SB, Actuator play in the axle, Soff-Cut 4000, 2022-04

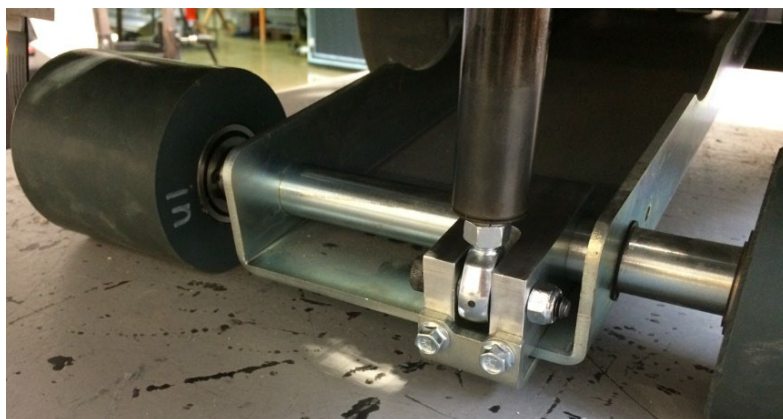
At a certain point when raising or lowering the saw, there is a "dead play". The undesired "dead play" causes the saw to be less smooth. It is irritating for the operator of the saw but does not affect the cutting result or performance during the cut.

A new actuator bracket is introduced and installed in a better way, which eliminates the "dead play".

The new Actuator bracket is product improvement only. Replace only if it breaks!

If the existing Actuator bracket needs to be replaced, order a new Retrofit kit PN 536651701.
